# Burke-Gilman Trail Missing Link

This was the Seattle Design Commission's (SDC) first review of the Burke-Gilman Trail Missing Link project since 2014. The purpose of this meeting was to review the concept design phase of the project. After the presentation, questions, and deliberation, the SDC voted, 9-0, to approve the concept design phase of the Burke-Gilman Trail Missing Link project with several recommendations.

**August 3, 2017****2:30 – 4:00 pm****Type**

Figure 4: Proposed ROW reallocation along NW Market St.

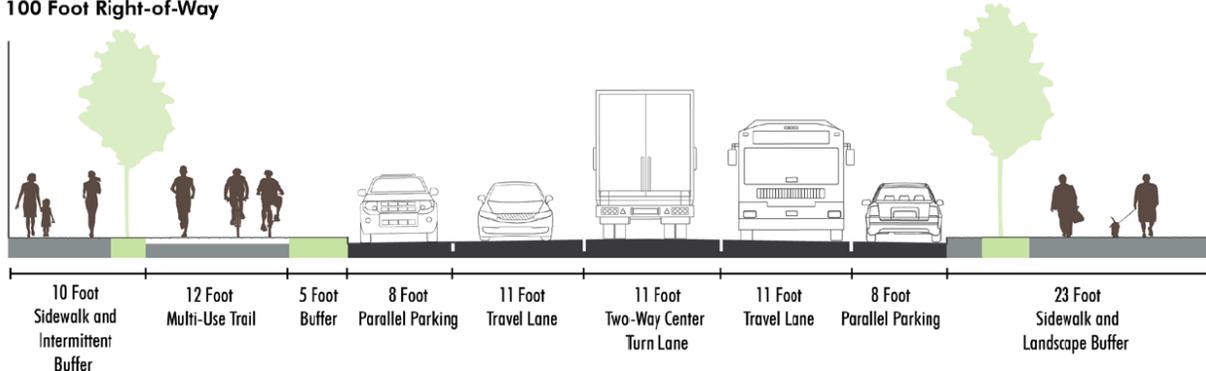
The SDC provided several comments concerning pedestrian and bicyclist safety along the proposed trail. Commissioners are concerned with the design proposal near the intersection of 24th Ave NW and Market St. The SDC recommended the team provide a design solution that will make cyclists slow or dismount prior to passing by the intersection. Commissioners are also concerned with bicyclist safety while crossing loading areas along NW 45th St. as well as the railroad track crossing. The SDC commended the design team for terminating 24th Ave NW prior to intersecting with Shilshole Ave NW.

- Continue to study circulation issues near the NW Market St and 24th Ave NW intersection. Study how bicyclists will interact with pedestrians near the southwest corner of the intersection.
- Consider providing additional planting and shade along the trail, specifically along Shilshole Ave NW.
- Continue to integrate the design with Nordic Heritage Museum and proposed Ballard Pump Station
- Consider providing more pedestrian amenities along the trail
- Further examine the angle at which the trail will intersect with the railroad tracks

Figure 5: Proposed ROW reallocation along Shilshole Ave. NW

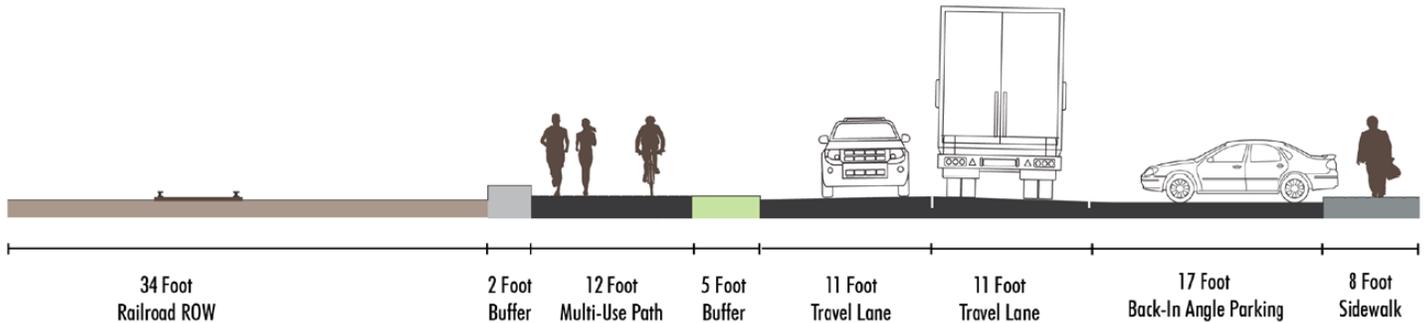
The SDC acknowledged the opportunity for the addition of landscape elements, such as street trees, low lying vegetation, and rain gardens, throughout the trail design. Commissioners agreed additional landscape improvement will provide shade throughout the trail while increasing the perceived separation between the trail and vehicular traffic lanes. Commissioners appreciated the level of detail and organization provided in the cross sections. Although the commission commended the project team for providing a grade separation between the proposed trail and adjacent street, several commissioners cautioned the design team from providing a grade separation between the pedestrian and cyclist sections of the trail. The commission commented that adequate separation between pedestrian and bicyclist could be achieved through proper wayfinding measures.
